UNITED STATES PATENT AND TRADEMARK OFFICE

APPLICATION NO.	FILING DATE	FIRST NAMED INVENTOR	ATTORNEY DOCKET NO.	CONFIRMATION NO.
10/531,513	11/01/2005	Theodor Gerhard Rosch	169-85304	9097
22342 7590 09/18/2008 FITCH EVEN TABIN AND FLANNERY 120 SOUTH LA SALLE STREET SUITE 1600 CHICAGO, IL 60603-3406				
EXAMINER				
OU, JING RUI				
ART UNIT		PAPER NUMBER		
3773				
MAIL DATE		DELIVERY MODE		
09/18/2008		PAPER

Office Action Summary

DETAILED ACTION

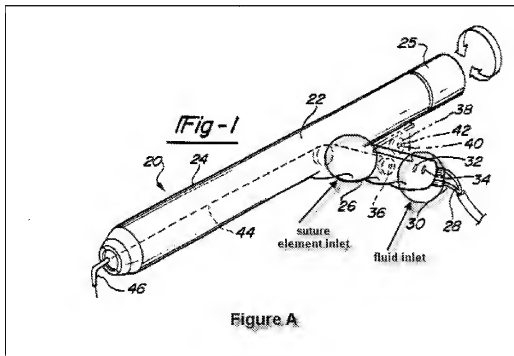
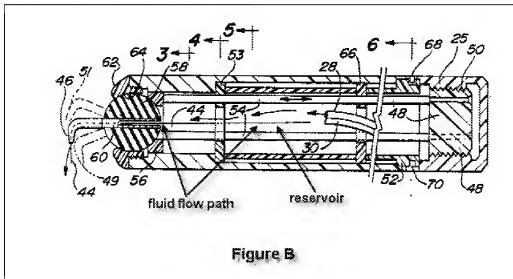
In regard to Claims 22-31, Weng discloses a medical implement (20), which includes a body (24) defining: tissue penetration means (46); a fluid flow path (see Figure B below); a fluid inlet (see Figure A below); an outlet (distal opening of 46); a suture element inlet (see Figure A below) which opens into the fluid flow path at a position intermediate the fluid inlet and the outlet; wherein the body defines a reservoir (see Figure B below); wherein the body defines a suture element feed path which intersect the fluid flow path at a position intermediate the fluid inlet and the outlet; the implement includes releasable securing means; and a tissue drive means (channel of 60); and wherein the fluid inlet and the suture element inlet are provided by a single inlet into the fluid flow path.
